**CITY OF TEMPE  
DEVELOPMENT REVIEW COMMISSION**

**Meeting Date: 11/13/2012**

**ACTION:** Request approval for a Development Plan Review for PORTILLO'S RESTAURANT, located at 65 S. McClintock Drive. The applicant is Rich Pozzi of Portillo's.

**BACKGROUND INFORMATION:** PORTILLO'S RESTAURANT (PL120042) is proposing a new 9,758 s.f. restaurant including a second story mezzanine and a double drive-through. The site is located on the southwest corner of Tempe Marketplace, at the north east corner of McClintock Drive and Rio Salado Parkway. The applicant received Development Plan Review approval for a previous design; however, due to input from the Commission, Property Owner and Development Team, the design concept for the project has changed, requiring review of a new design. The request includes the following:

**SP-1**  
SHEET 1 OF 1

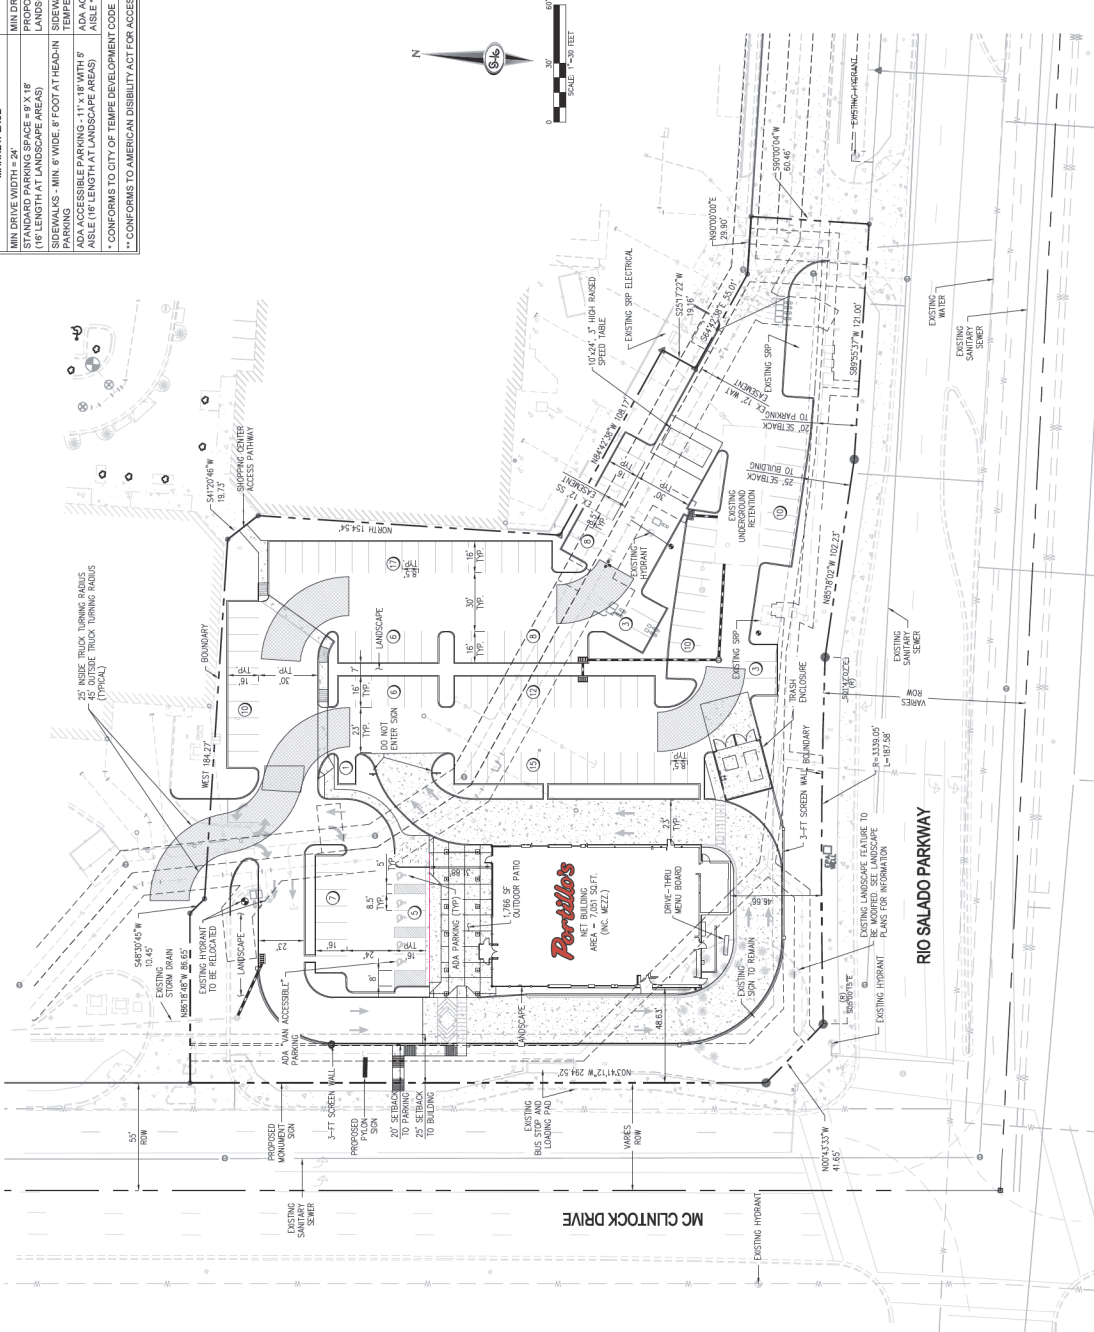
1. Provide service yard and mechanical yard walls that are at least 8'-0" tall as measured from adjacent grade and are at least the height of the equipment being enclosed, whichever is greater. Verify height of equipment and mounting base to ensure that wall height is adequate to fully screen the equipment.

2. Provide gates of steel vertical picket, steel mesh, steel panel or similar construction. Where a gate has a screen function and is completely opaque, provide vision portals for visual surveillance. Provide gates of height that match that of the adjacent enclosure walls.

3. Provide upgraded paving at each driveway consisting of unit paving. Extend this paving in the driveway from the right-of-way line to 20'-0" on site and from curb to curb at the drive edges. From sidewalk to right-of-way line, extend concrete paving to match sidewalk.

**1 WEST EXTERIOR ELEVATION**  
 Scale: 3/16" = 1'-0"

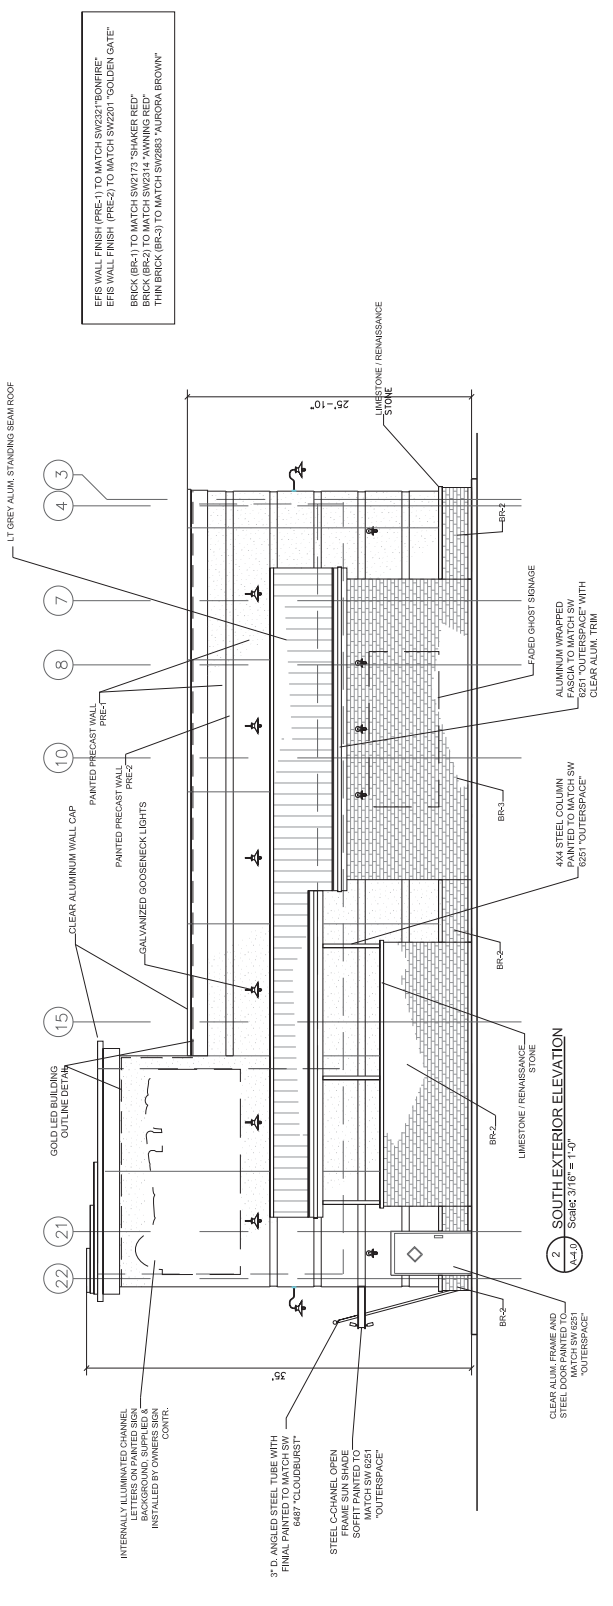
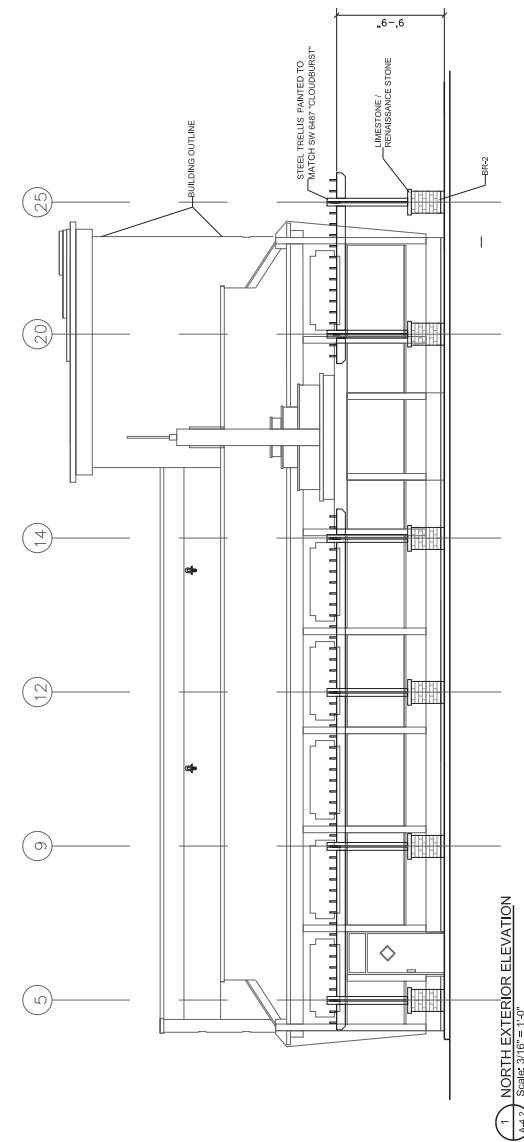
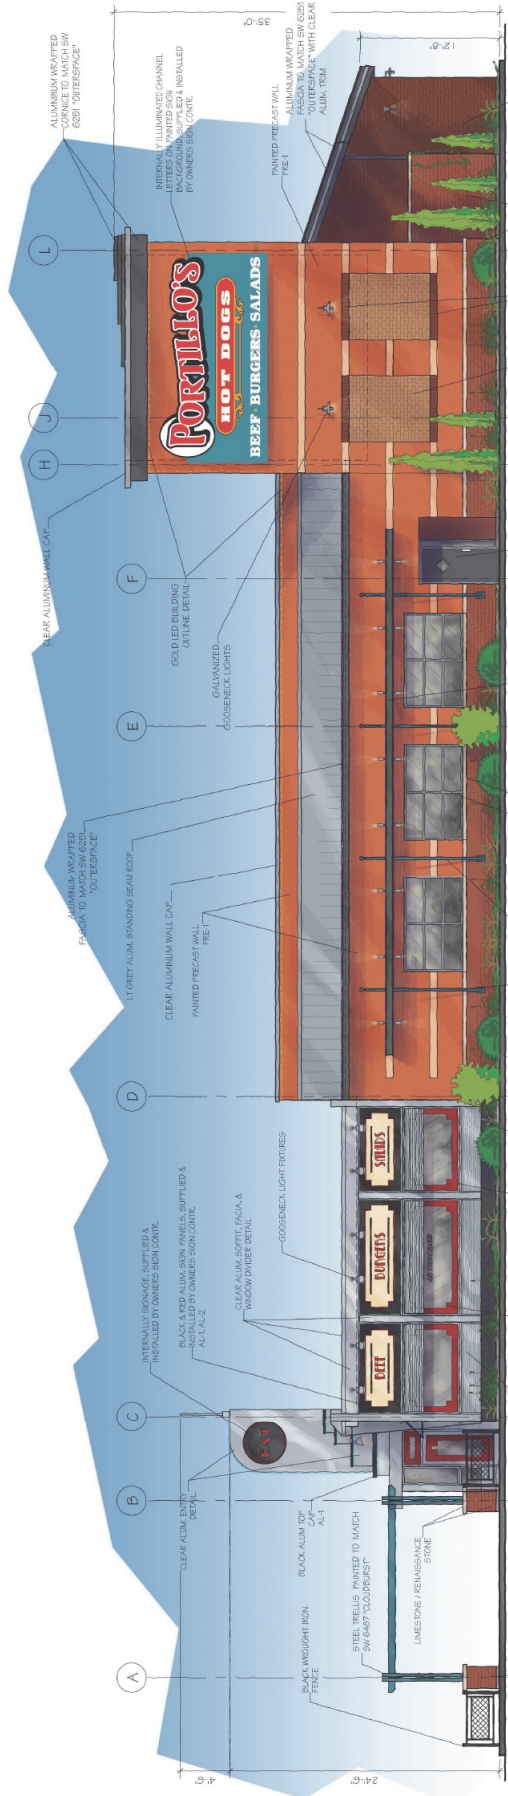
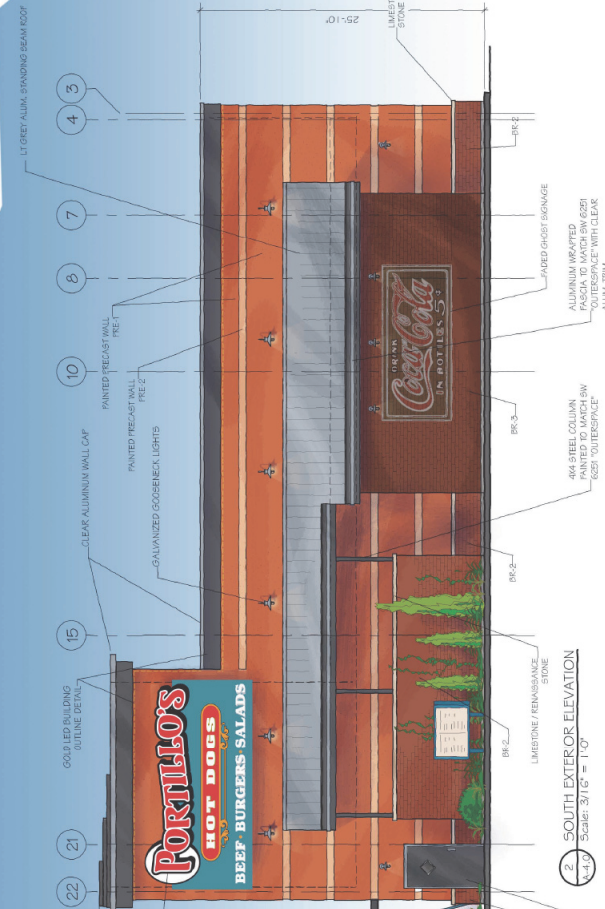
6. The materials and colors are approved as presented:  
Parapet and standing metal seam roof  
North end primary building - Stainless Steel Diner Car Siding and corrugated stainless steel siding and trim

North end trim – Aluminum Diner Car Red  
 North end trim accent– Aluminum Diner Car Black  
 Primary building – Precast painted concrete Sherwin Williams SW2321 Bonfire (medium rust/brown brick)  
 Accent building – Precast painted concrete Sherwin Williams SW2201 Golden Gate (muted gold)  
 Window sill – Limestone/Renaissance Stone  
 Faux windows and accent brick – Copper Mission (medium tan)  
 Wainscot, south end screen wall and accent brick – Inca Smooth (traditional brick red)  
 Faux window trim and south end primary building brick – Vintage Mission (chocolate brown)  
 Trim – painted Sherwin Williams SW6251 Outerspace (dark cool grey)  
 Metal Canopies, Standing Metal Seam Roof , angled steel tube with finial – painted Sherwin Williams SW6487  
 Cloudburst (light cool grey)  
 Window frames – clear anodized aluminum  
 Low-E rated tempered glass  
 Provide main colors and materials with a light reflectance value of 75 percent or less. Specific colors and materials exhibited on the materials sample board are approved by planning staff. Additions or modifications may be submitted for review during building plan check process.

7. Provide secure roof access from the interior of the building. Do not expose roof access to public view.
8. Conceal roof drainage system within the interior of the building.
9. Incorporate lighting, address signs, and incidental equipment attachments (alarm klaxons, security cameras, etc.) where exposed into the design of the building elevations. Exposed conduit, piping, or related materials is not permitted.
10. Locate the electrical service entrance section (S.E.S.) inside the building or inside a secure yard that is concealed from public view.
11. Upper/lower divided glazing panels in exterior windows at grade level, where lower glass panes are part of a divided pane glass curtain-wall system, shall be permitted only if laminated glazing at these locations is provided.
